Design Review Report – Item 1

Local government:	City of Stirling	
Item no.:	Item 1 - DA24/1064 – 308 Main Street, Balcatta – Development Assessment Panel – Form 1 – Child Care Premise	
Acting Chairperson:	Philip Gresley	
Panel members:	Tony Blackwell Jackson Liew Lisa Shine	
Local government officers:	Peter Prendergast James Fletcher Dean Williams Shaun Wheatland Simone Palmer	Acting Manager Acting Service Lead Planning Coordinator Planning Senior Planning Officer DRP Support Officer
Observers		
Date:	29 August 2024	Time: 3pm
Venue:	City of Stirling – Challenger Room

Design quality evaluation Item 1 – DA24/1064 – 308 Main Street, Balcatta – Development Assessment Panel – Form 1 – Child Care Premise DRP Meeting – Thursday 29 August 2024		
	S	<i>Design Principle satisfied</i>
	P	<i>Design Principle pending further attention</i>
	N	<i>Design Principle not satisfied</i>
Principle 1 Context and character		<i>Good design responds to and enhances the distinctive characteristics of a local area, contributing to a sense of place.</i>
	N	1a. Whilst the location of the proposal (and some technical contextual issues) was presented, the Panel noted that there was limited information provided

PROPOSED ELEVATIONS

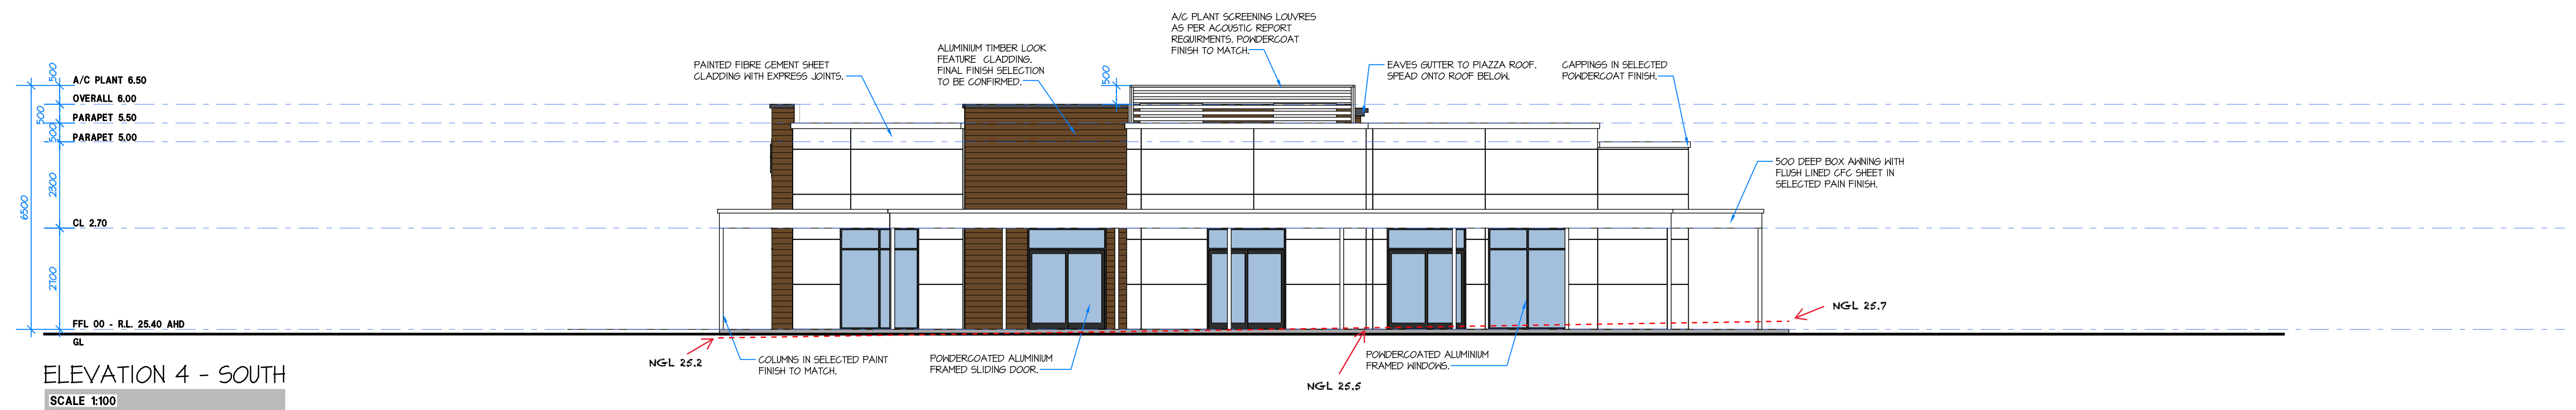
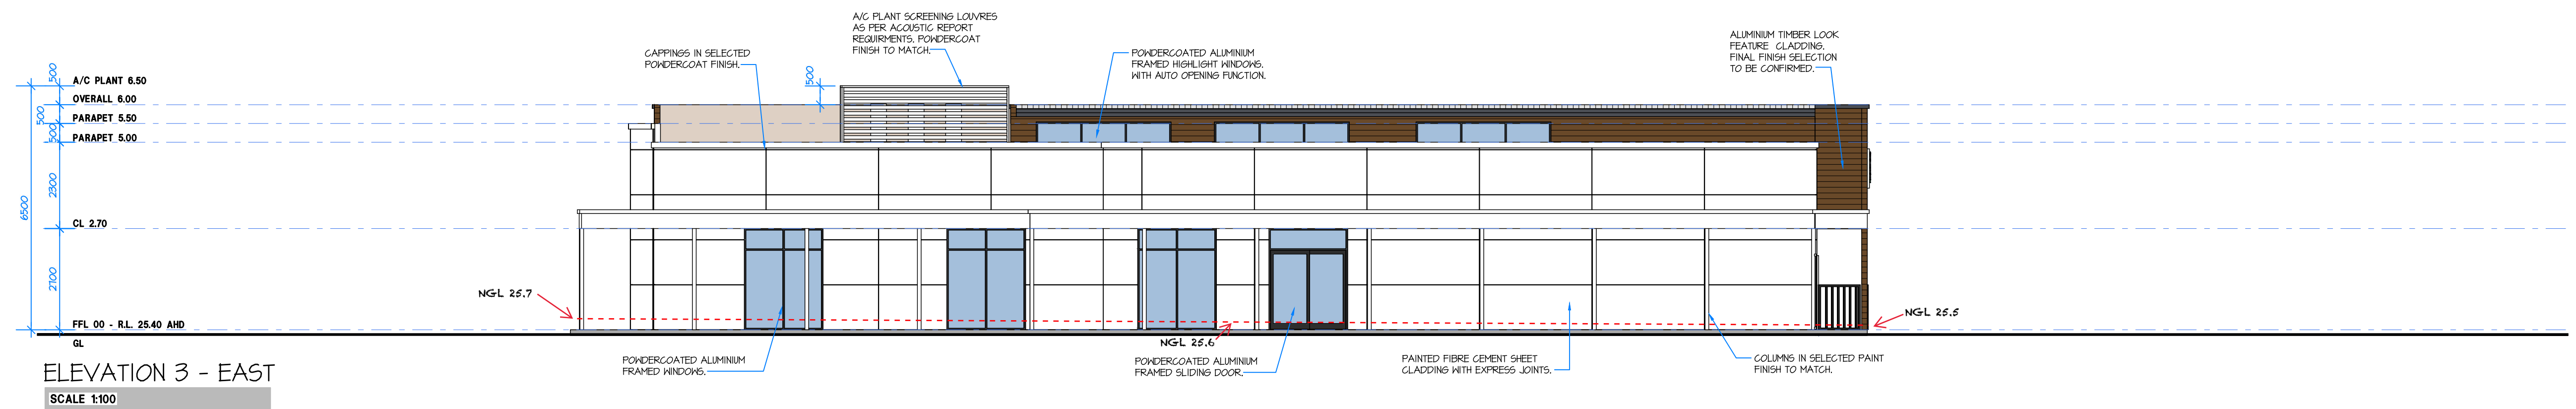
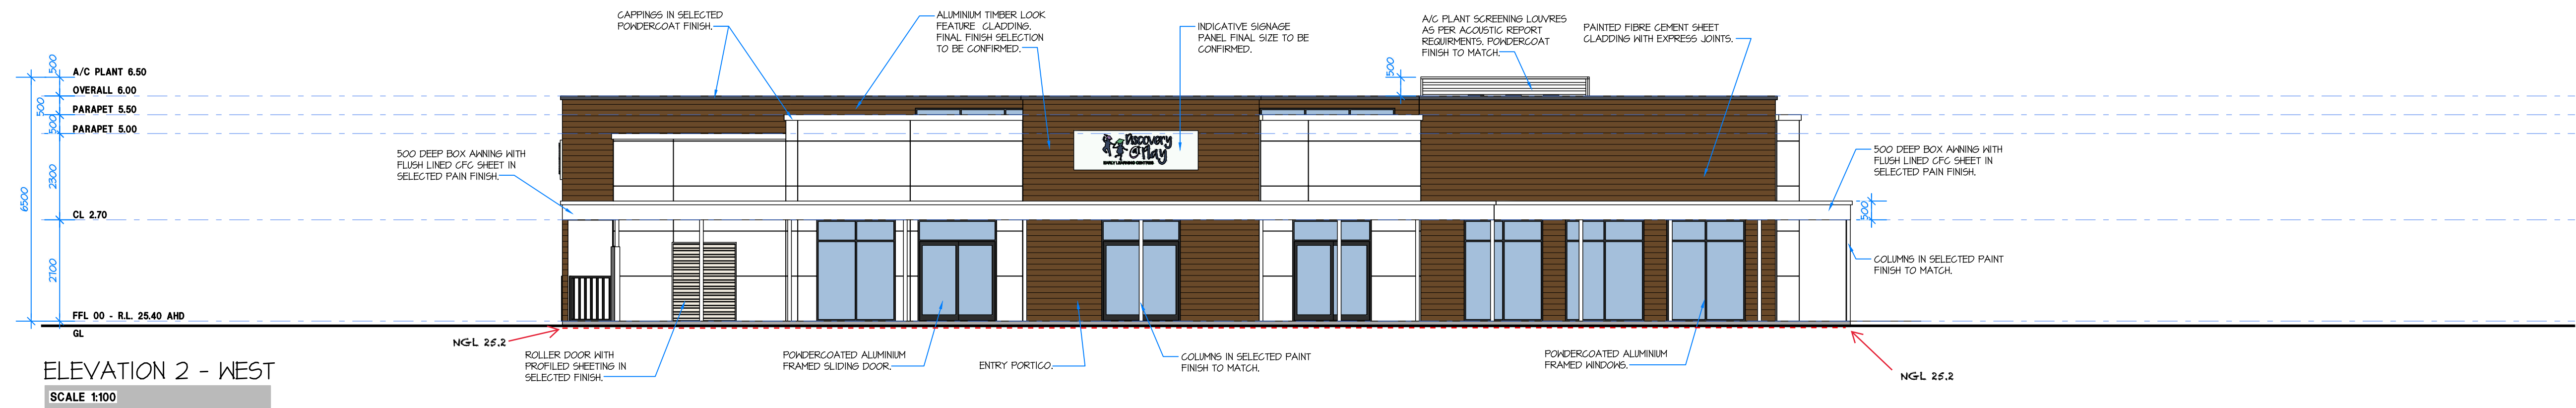
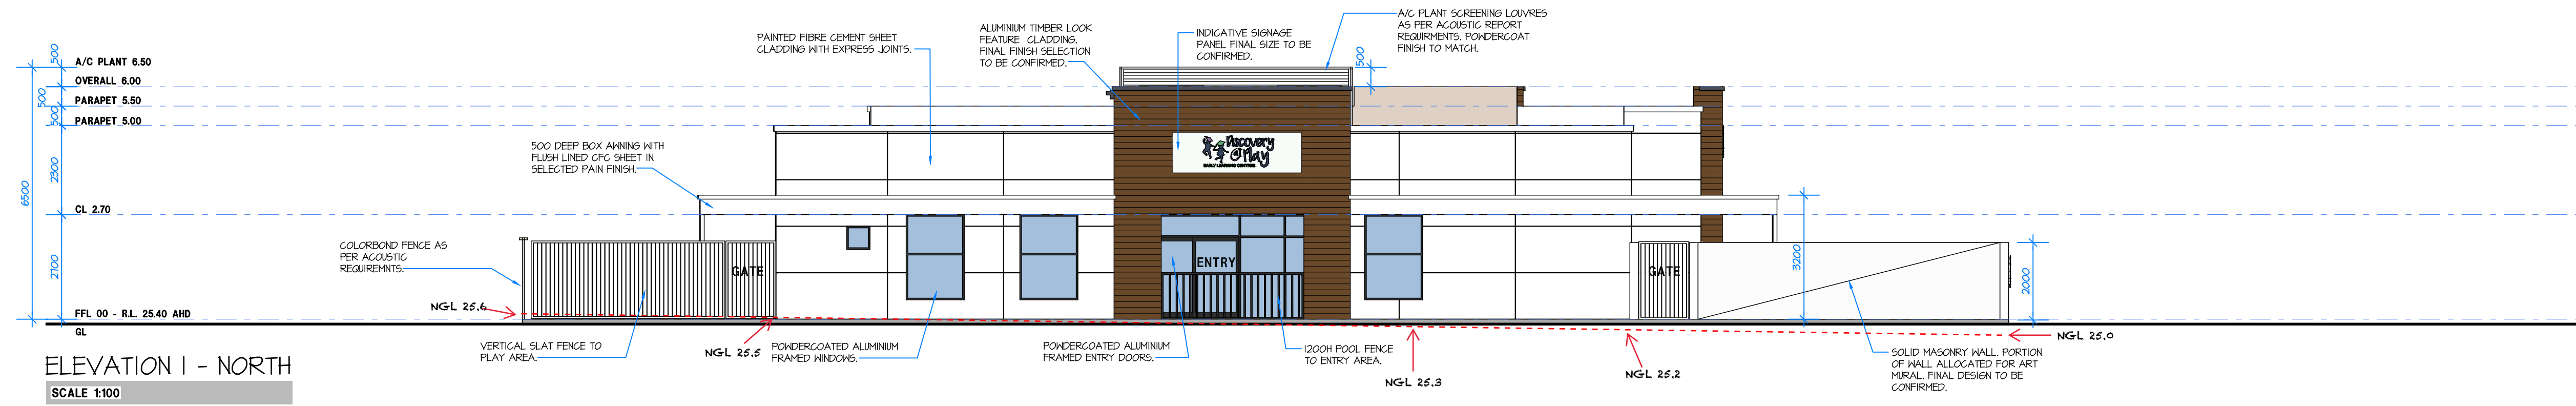
4i.	Concerns were raised about the use of Perspex in the fencing to meet acoustic requirements. Perspex can degrade significantly over time and is generally not very UV stable. Alternative materials should be considered plus alternative approaches to managing this important interface should be considered.			
5c.	The Applicant was strongly encouraged by the Panel to explore sustainability initiatives and suggested engaging the services of a sustainability consultant. A commitment to sustainability initiatives is essential to enable a successful outcome and further clarity was requested.			
6a.	The seating provided at the entry for clientele to stop and chat is welcoming, positive and good practice, however generosity in this area could be improved.			
6b.	It was noted by the Panel there are no windows indicated in the cot room on the drawings. The cot room should include an openable window to purge overnight and enable natural light penetration.

renders as they impact considerably the aesthetic outcomes. 10g. The location and detailing of downpipes and other detailed service elements should be considered with relation to aesthetic appeal. 10h. A suggestion was made by the Panel there is opportunity to explore a more playful approach to the black safety fence at the entrance.			
--	--	--	--
